SUNSET

TOWN OF ERIE, COLORADO
TOWN BOARD

MAY 2020

SUNSET PLAN CHANGES

Plat Comparison

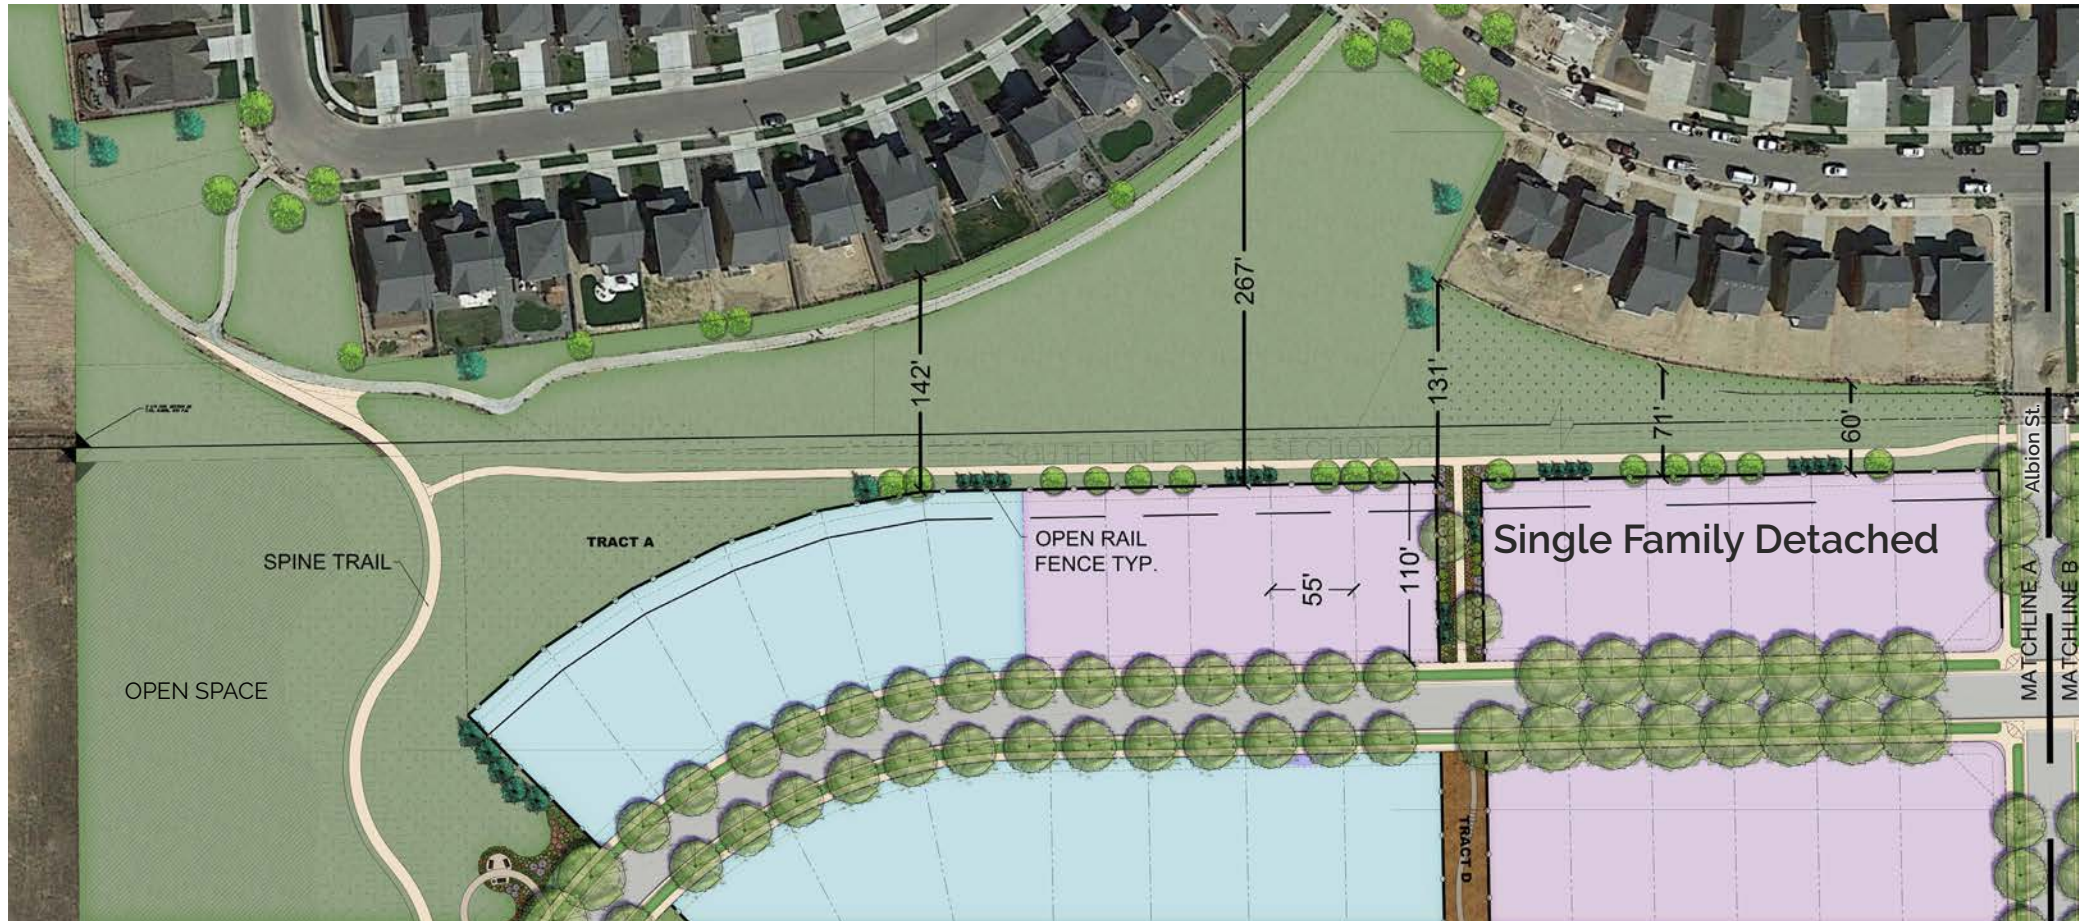
- Neighborhood Meeting originally scheduled for March 12, 2020 rescheduled for a virtual meeting on April 30, 2020. Notice included a Zoom link.
- Replace 10 Paired home lots adjacent to Erie Highlands with 7 - 55 feet wide single family detached lots.
- Working with Crestone Peak Resources to plug and abandon the remaining 3 producing wells
- Replace oil well site with 11 new 65 foot wide lots and 2.04 acres of usable open space

Previous Plan

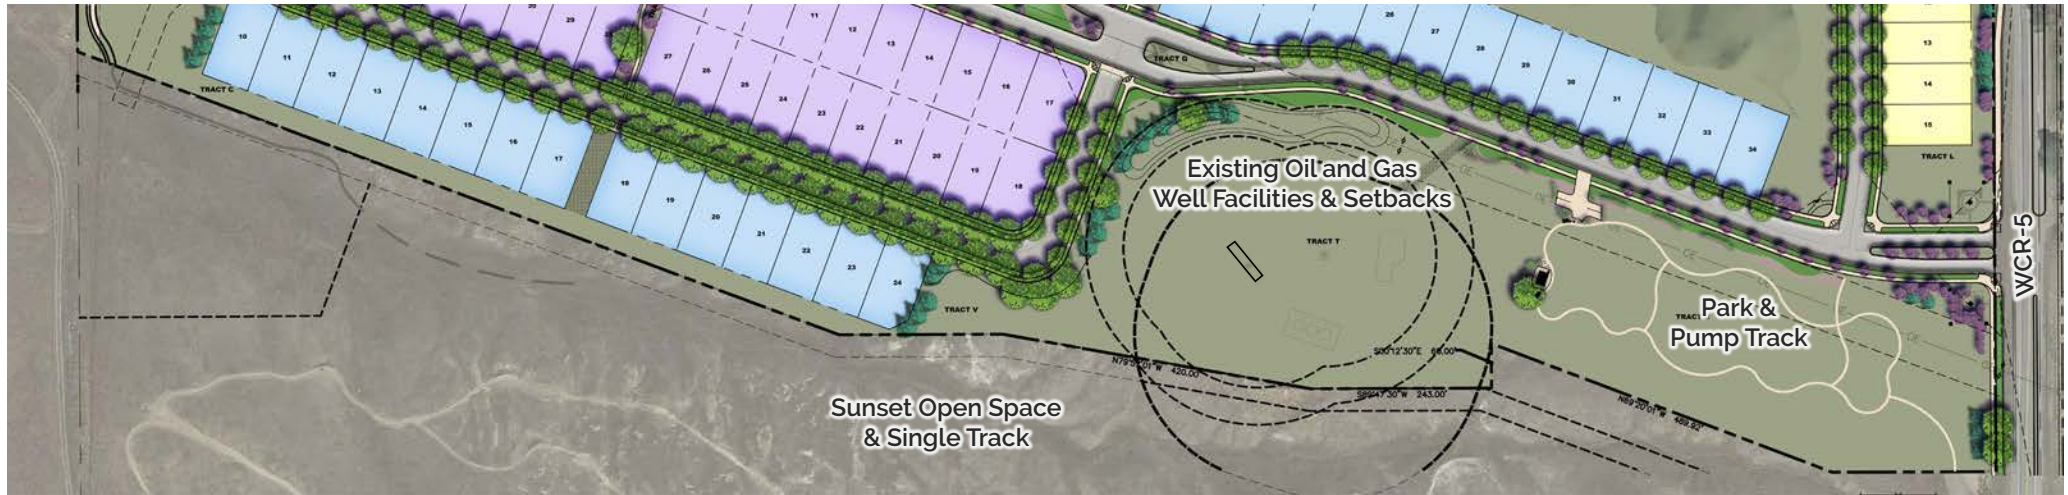
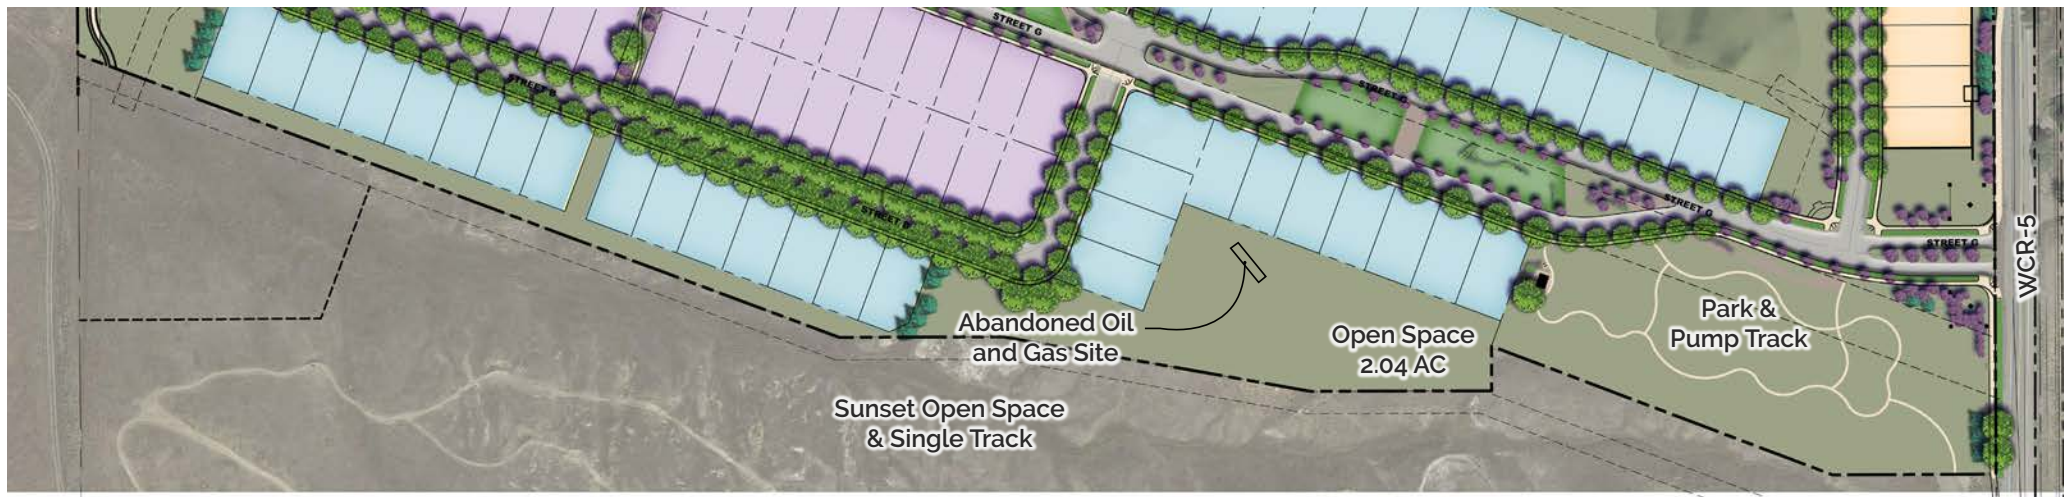
- Clarify separation of homes to the travel lanes on WCR 5
- Provide additional social trail access points into the open space
- Provide summary of environmental studies.
